WP 112-86-01 (B) DIST 8
HWY 15 STR SITE 16-45

Morton Creek Bridge Replacement

FOUNDATION INVESTIGATION REPORT
For
Morton Creek Bridge Replacement
W.P. 112-86-01 (B), Site No. 16-45
Highway 15, District 8, Kingston

PROFILE HWY 15

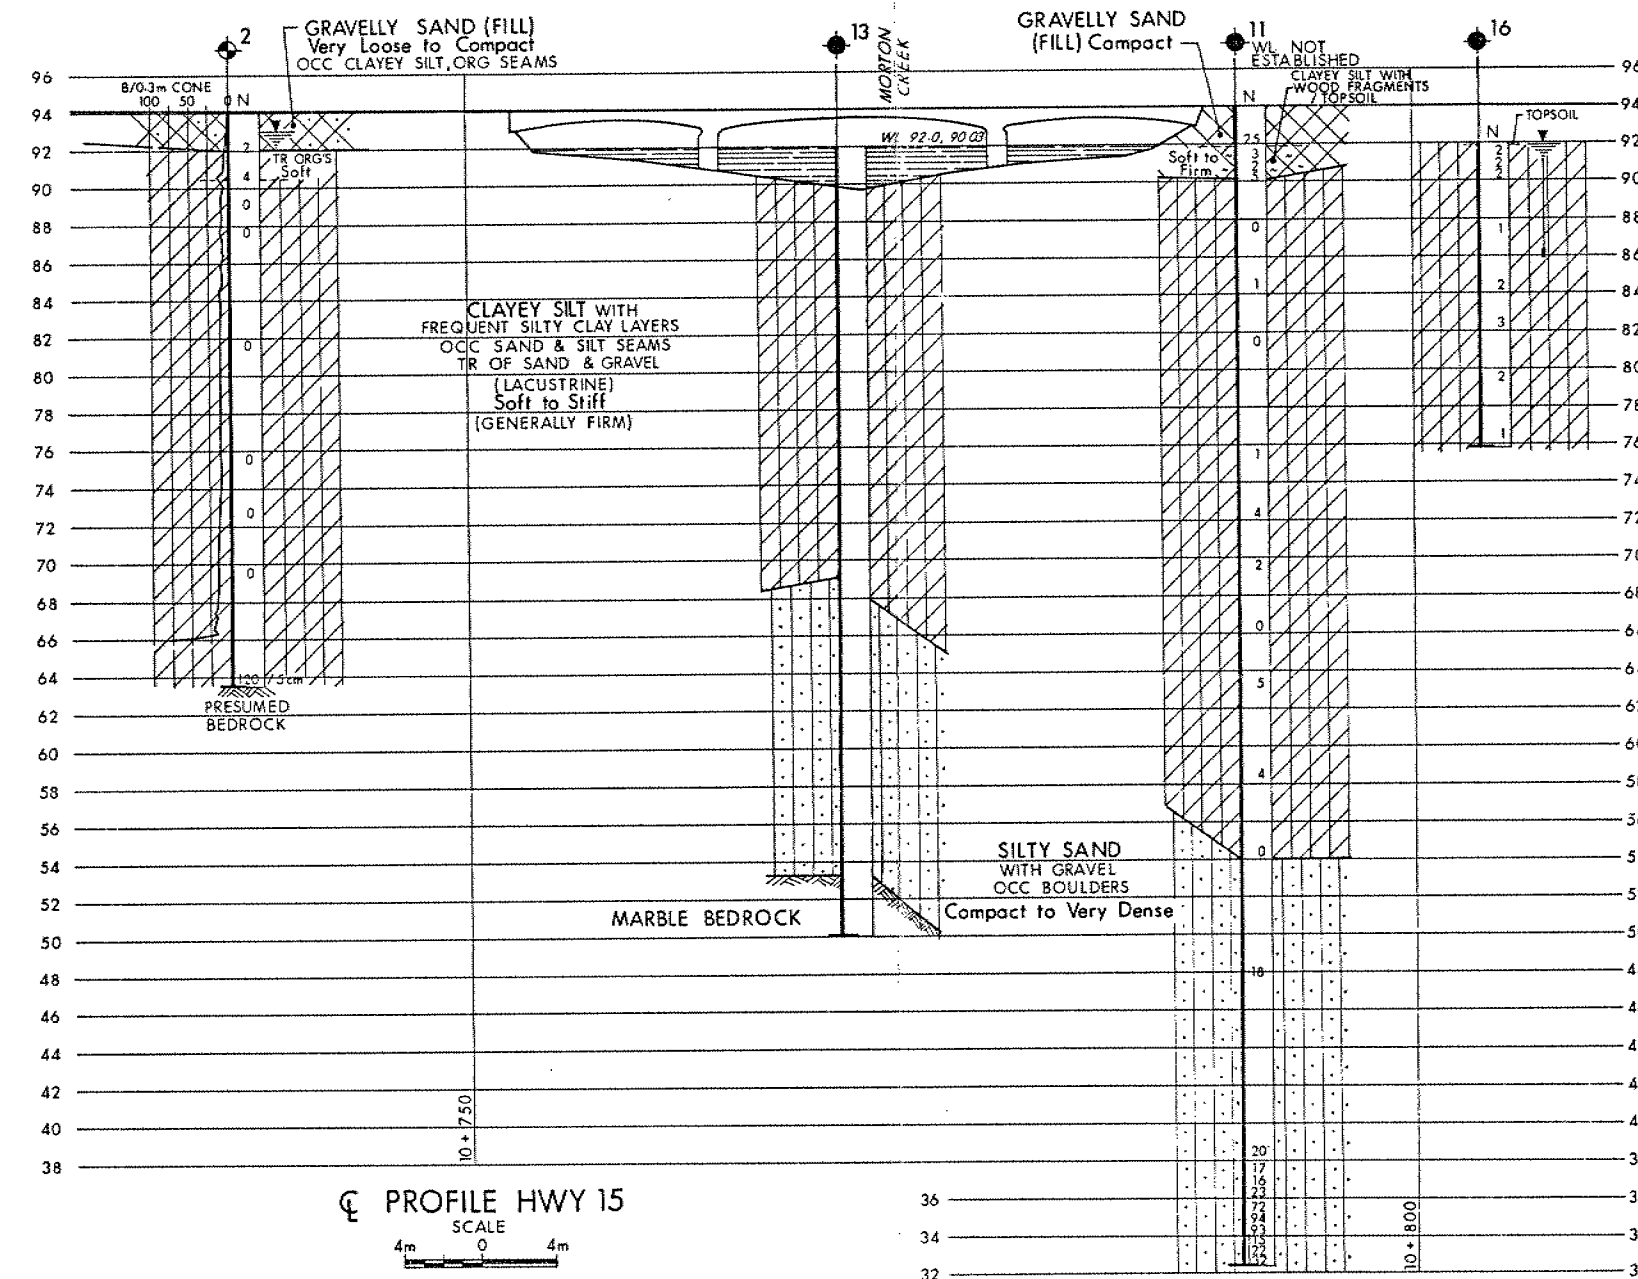
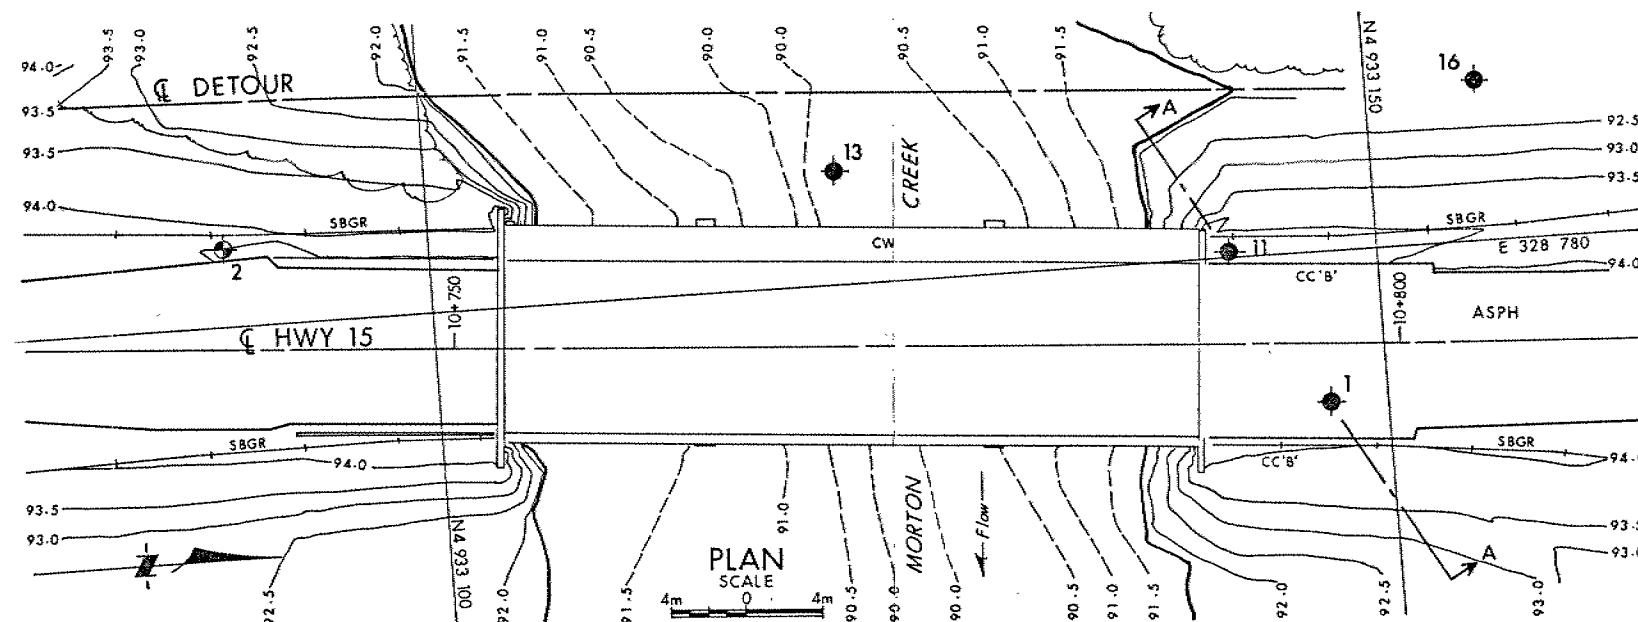
We have reviewed the General Arrangement Drawing No. P1 for the above noted structure. Our comments are as follows:

As reported in the foundation investigation report dated 90 05 25, a deposit of organic material was discovered under the north approach. It was recommended that this organic material should be removed in order to minimize the reported settlement. We believe this will be noted on the final drawing.
